**ERECTION OF TWO DETACHED DWELLINGS WITH GARAGES  
EXTENSION TO GRAVEYARD AND PROVISION OF NATURE GARDEN FOR PRIMARY SCHOOL  
LAND AT RISING SUN HILL  
RATTLESDEN**

## **Consultee Comments for application 2194/16**

Application Number: 2194/16

Proposal: Erection of two detached dwellings with garages. Extension to graveyard and provision of nature garden for primary school.

CLIENT: Mitchell Clarke  
SITE: Land Off Rising Sun Hill, Rattlesden  
DRG: Tree Survey & Constraints Plan  
DRN BY: GH  
SCALE: 1:250 @ A1  
DATE: July 2015  
No: LSDP 11254.01 Rev A

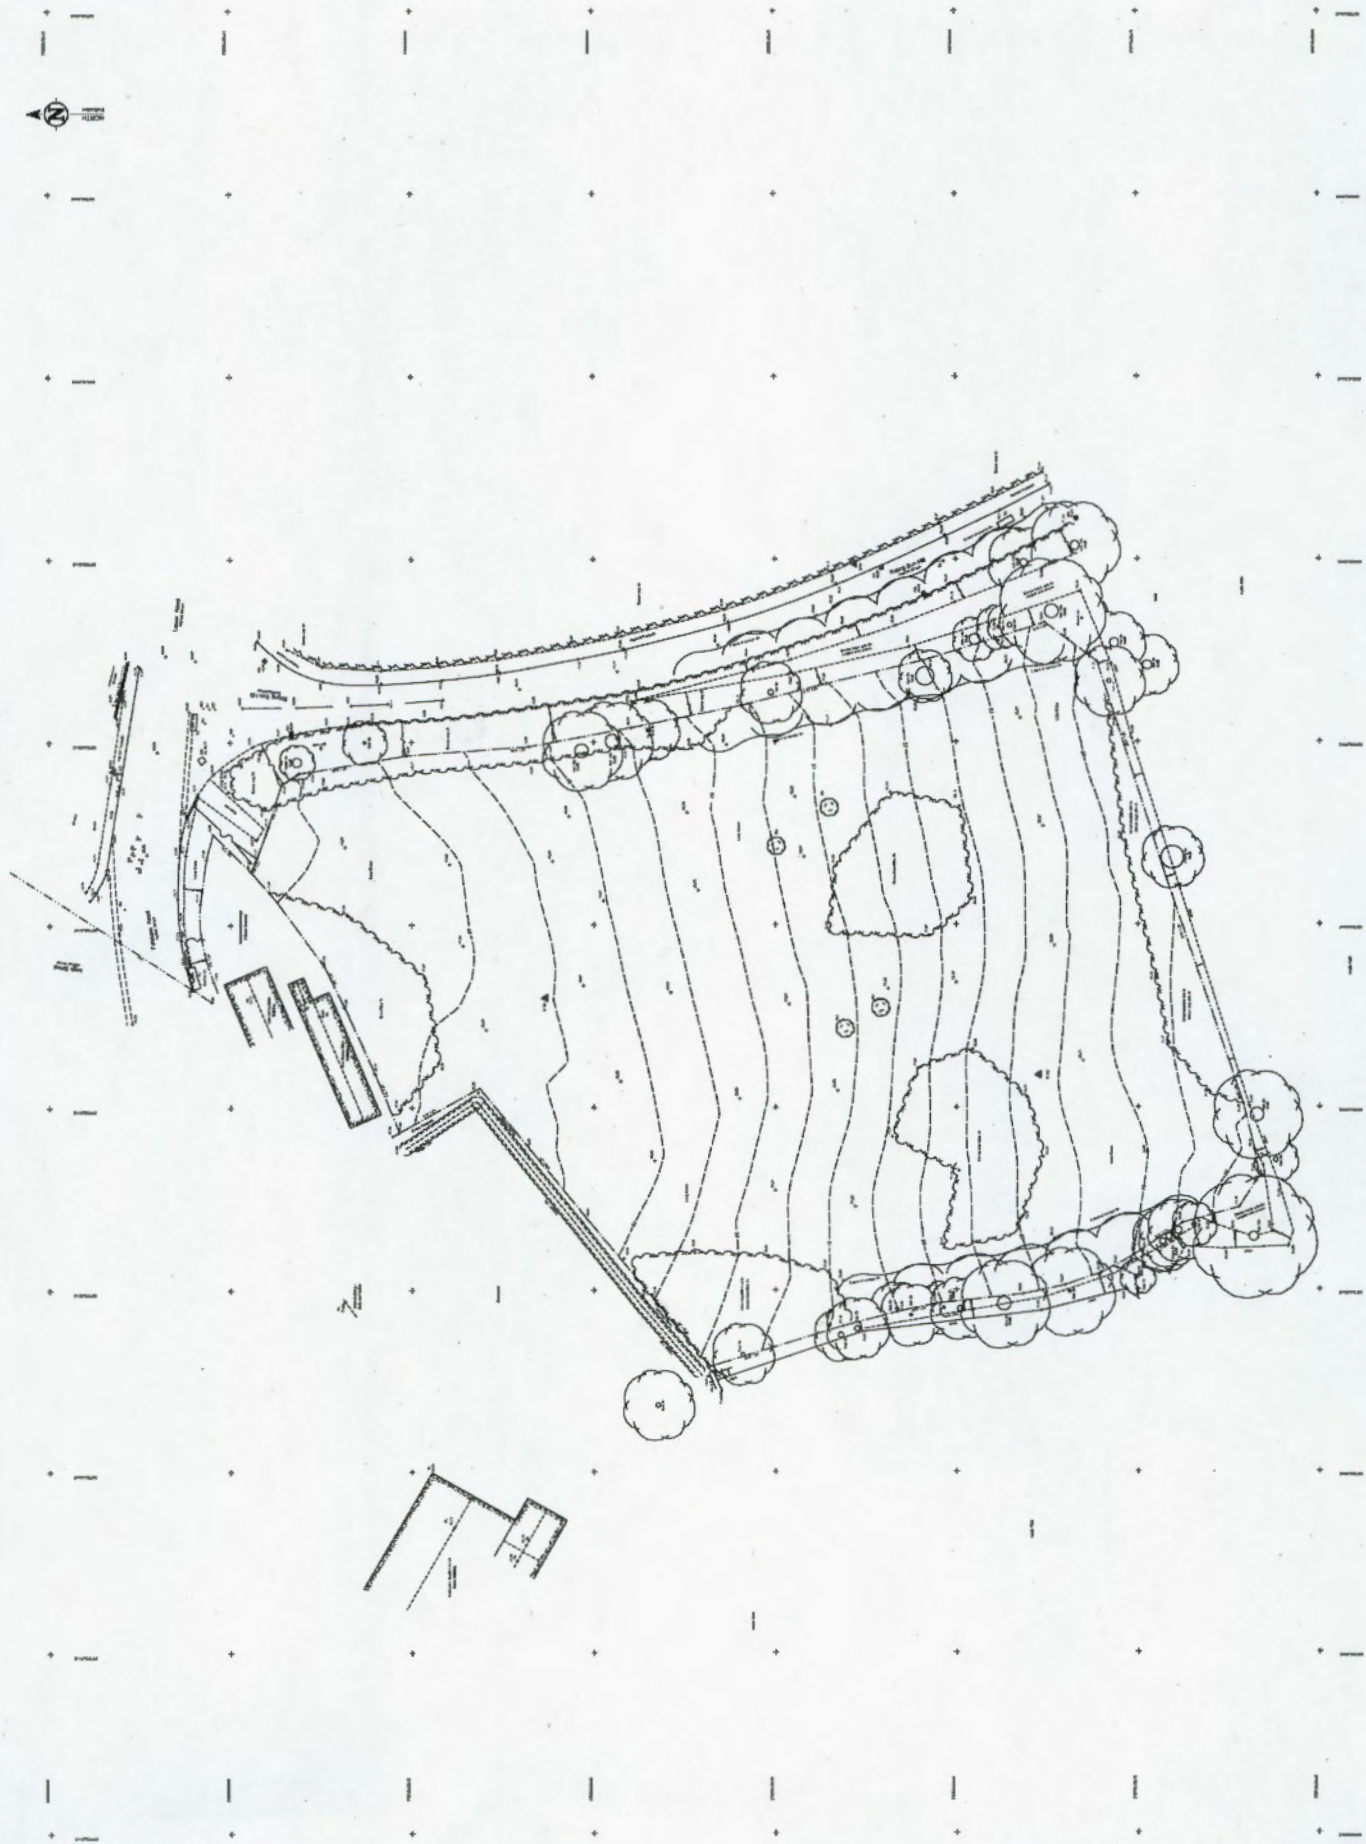
The LSDP plan 11254.01 Rev A identifies some broad landscape proposals for the garden and plot areas. The proposals seek to mitigate the visual impact of the development. It should be noted however they are not capable of addressing the impacts on the character of the site and its reasons for designation as a VIOS or the likely adverse impacts of the proposed access on the mature roadside hedgerow.

4. I do not consider that there is a need to carry out any further 'facing up' of either the west or roadside boundary hedges. I see no need to plant a new hedgerow close to the west boundary hedge and deep watercourse. New planting in close proximity to existing mature hedge/tree may detract from the high quality of the landscape feature. I would however wish to see a buffer zone between the garden boundaries and the boundary hedges to ensure their value is not undermined. This could achieve a similar effect to that of the field margin on the west side of the hedge.

FRONT ELEVATION PLOT 2 (NORTH)

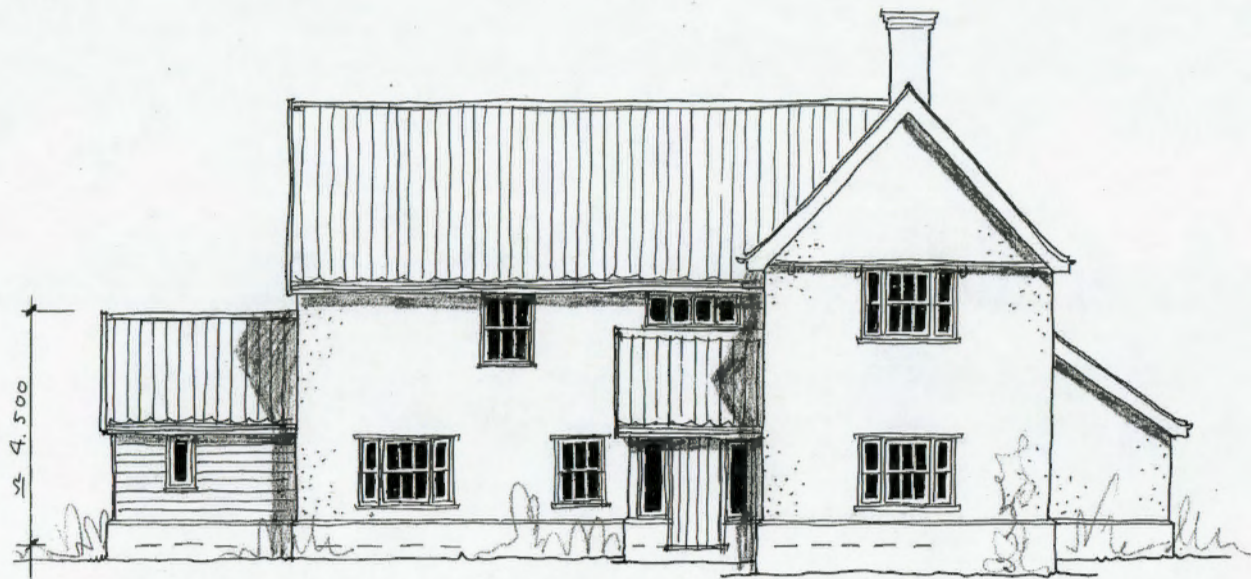
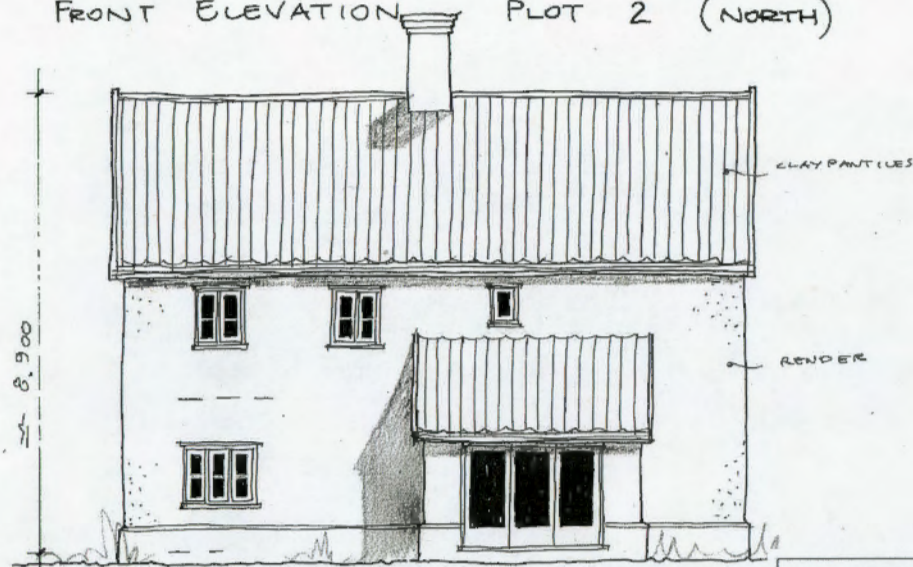
There is however one issue with the design. The property at plot 2 appears to face into the driveway in its north elevation but on its eastern elevation the symmetry appears rather contrived, as though it were also trying to be a facade. Traditionally, gable ends – which are effectively side elevations, and therefore of less architectural and social significance – are blank, or at least feature fewer openings than the formal front.
